ADDENDUM ORDER

ORDER NO. 1
DATE: 8/17/26
BID DATE: 8/26/26

NAME OF PROJECT: Desert Road Pump Station

OWNER: Clifton Water District

P1

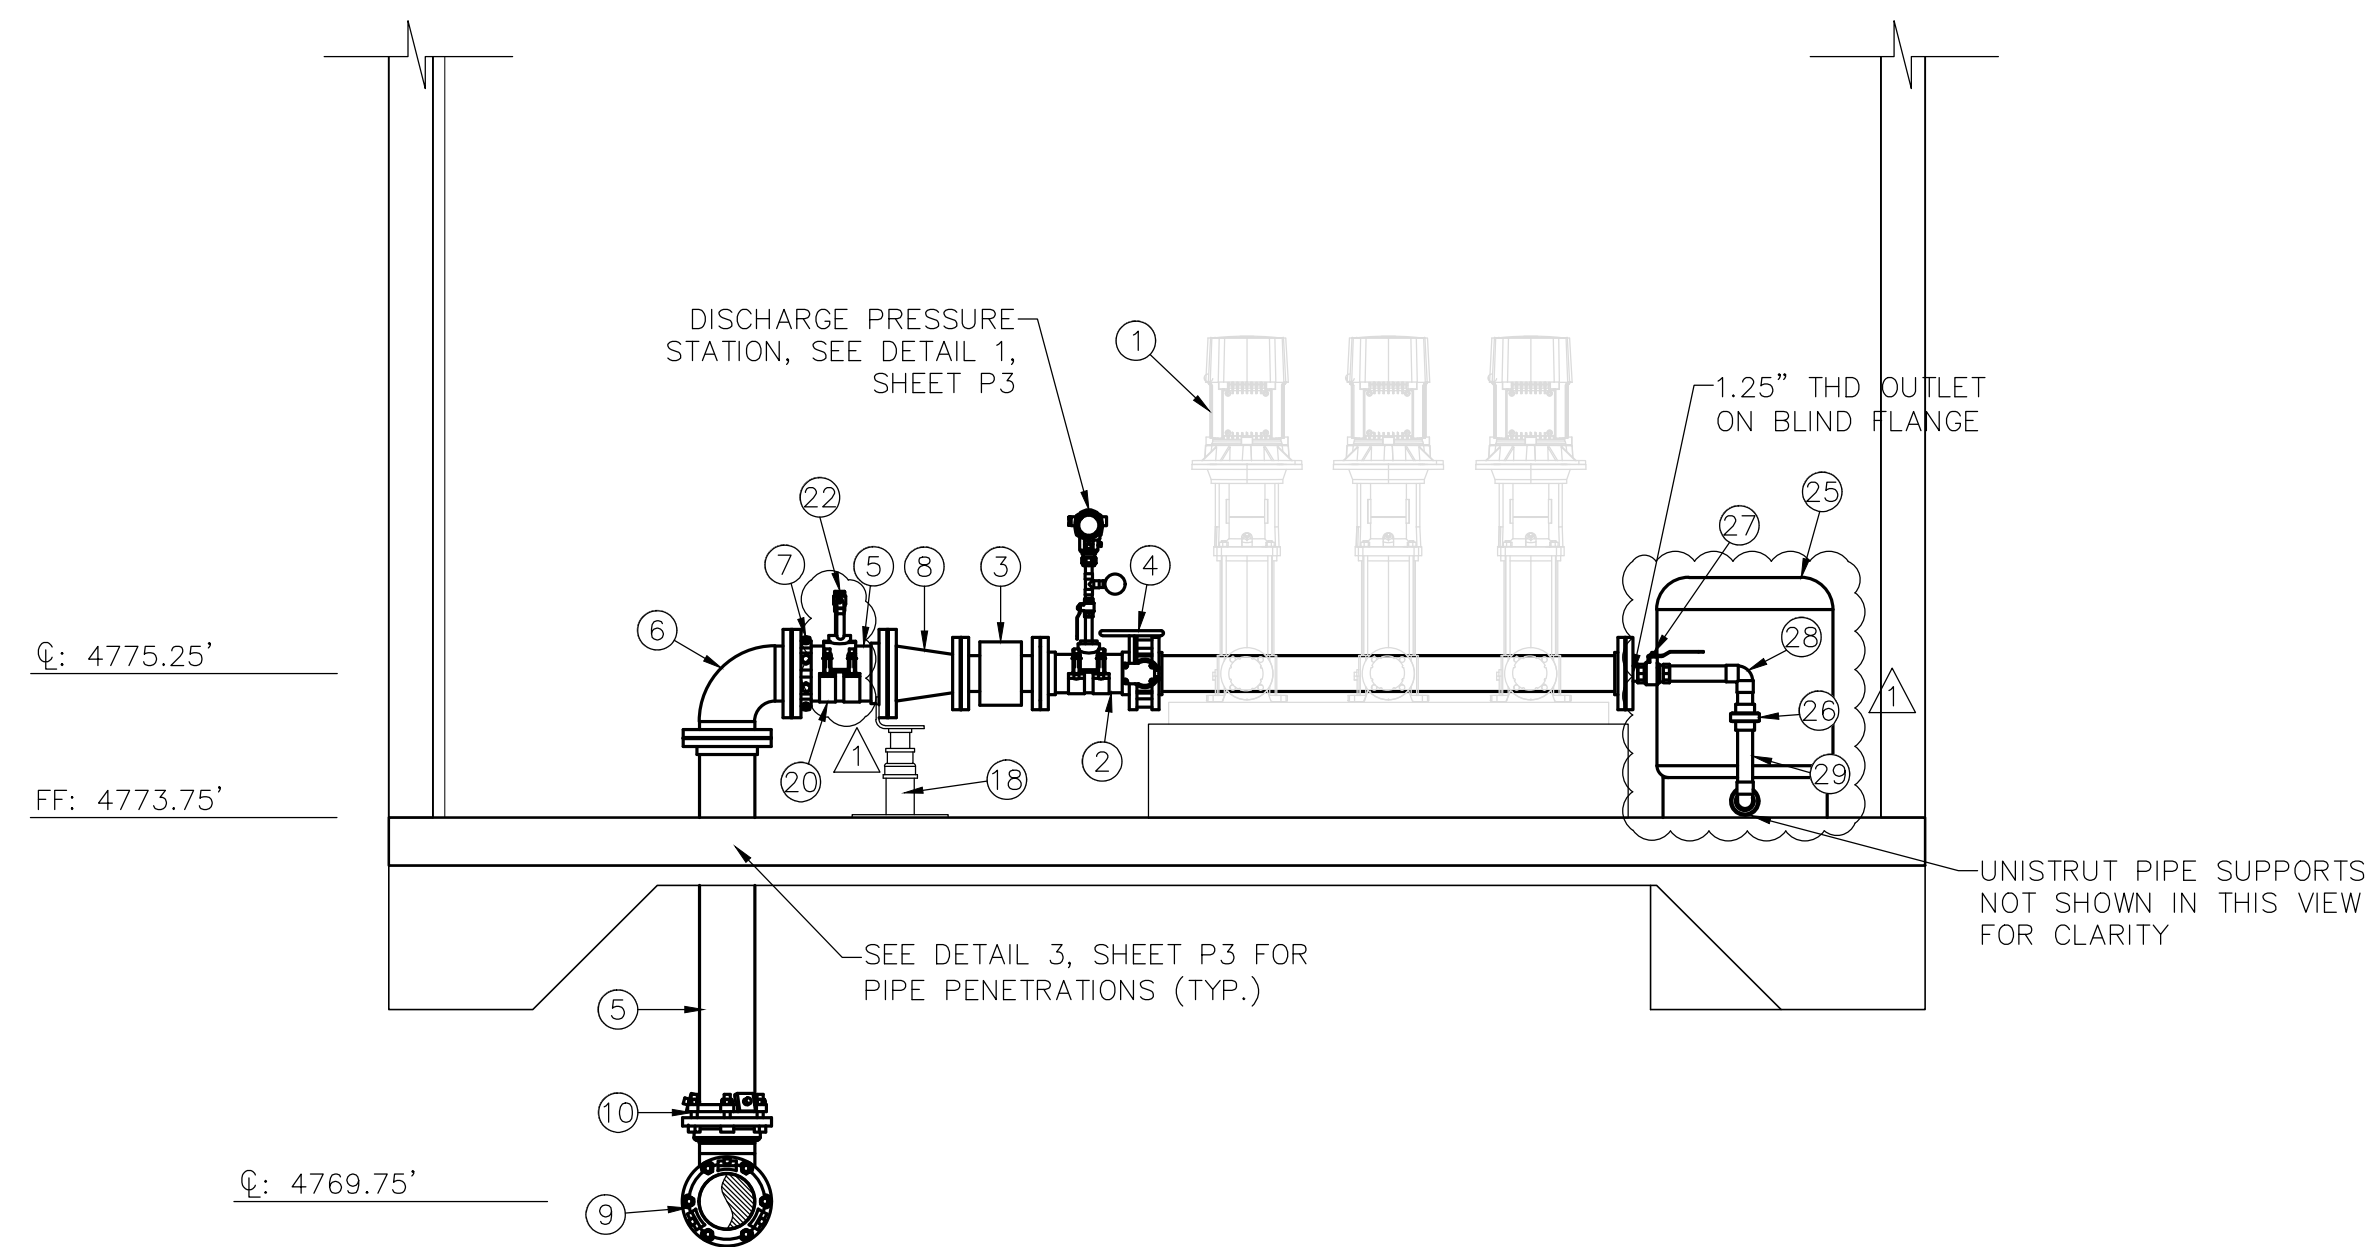
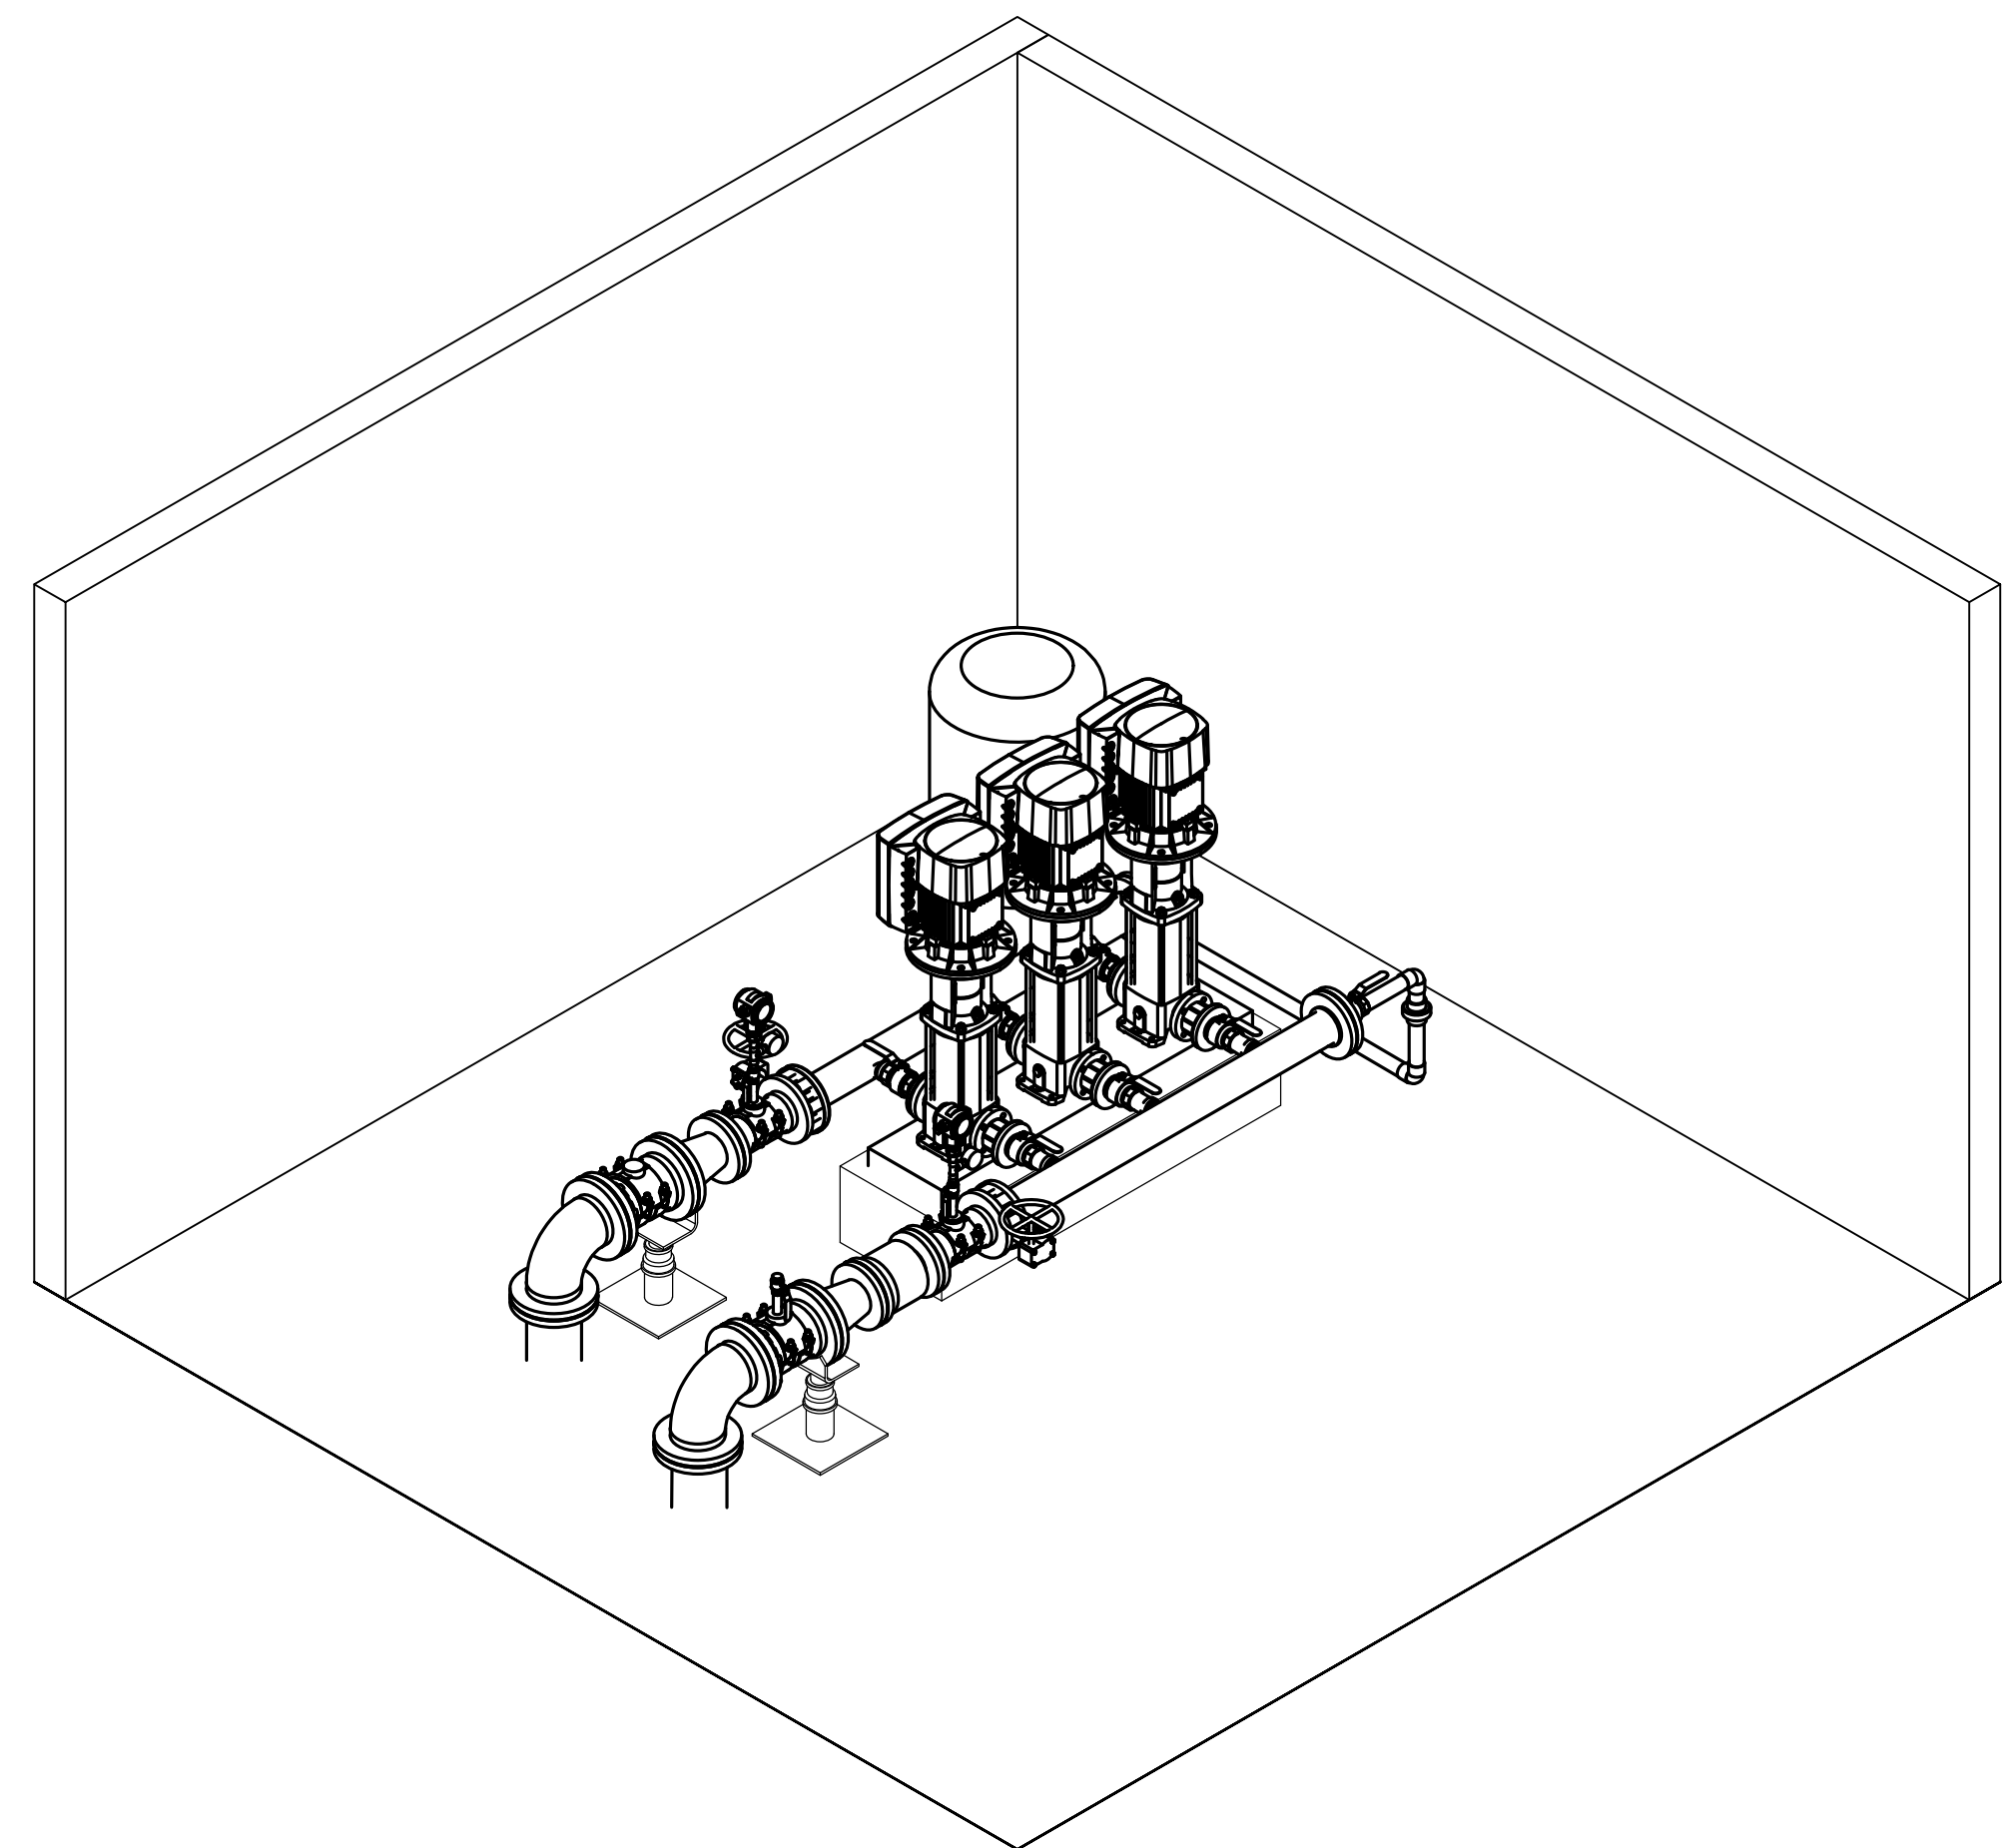
1. **Sheet C2**
 - a. Change suction side hot tap to cut in tee with valve
 - b. Added valve at suction side cut in location
2. **Sheet P1**
 - a. Added tap saddle and ball on suction piping
 - b. Added tap saddle and chemical injection quill on discharge piping
 - c. Added connection for expansion tank. (Expansion tank part of pump skid package. Piping and valves connecting pump skid and expansion tank is contractor responsibility)
